## MPC8315E Chip Errata

This document details all known silicon errata for the MPC8315E, MPC8315, MPC8314E, and MPC8314. The following table provides a revision history for this document.

**Figure 1. RGMII AC Timing diagram**

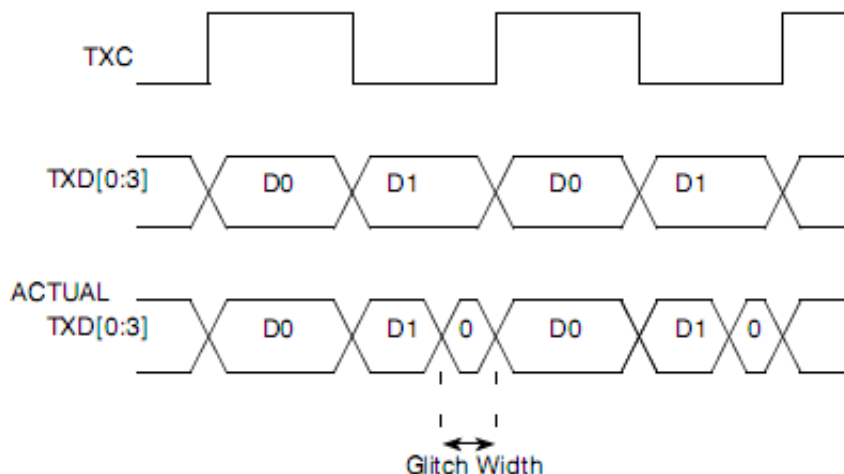
Effective data (D1) valid width for etsec2 =  $4\text{ns} - 0.9\text{ns} = 3.1\text{ns}$

This may lead to AC specification violation at the PHY and incorrect data capture. Also, RGMII 1000 may not work correctly.

**Impact:** RGMII mode may not be functional, if external RGMII PHY requires a tighter specification.

**Fix plan:** Fixed in Rev 1.1

**Figure 2. Recommended connections for DDR controller and memory**

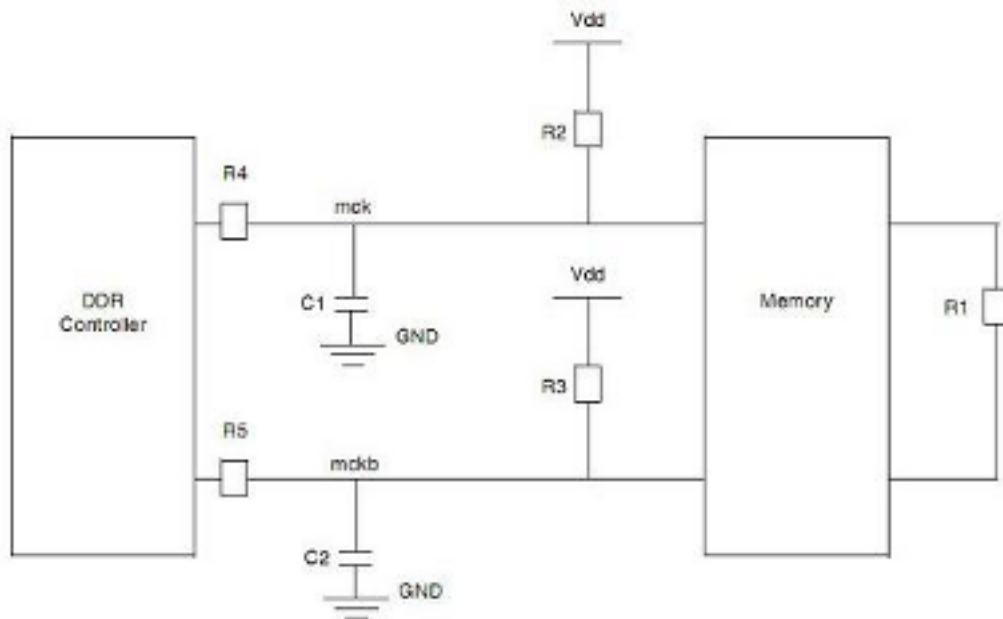
**Impact:** Disagreement with the JESD79-2C standard.

**Workaround:** To meet the JESD79-2C crosspoint voltage specifications, we recommend implementing the following connections between the DDR controller and DDR2 memory:

We recommend varying termination resistor R1 first. Lowering R1 can help increase the voltage levels up. The only disadvantage is that it may add up more reflections. Therefore, the user must decide accordingly. If it does not give sufficient margin, the user can add the pull-up resistor (R3 and R4) option to further increase the voltage levels.
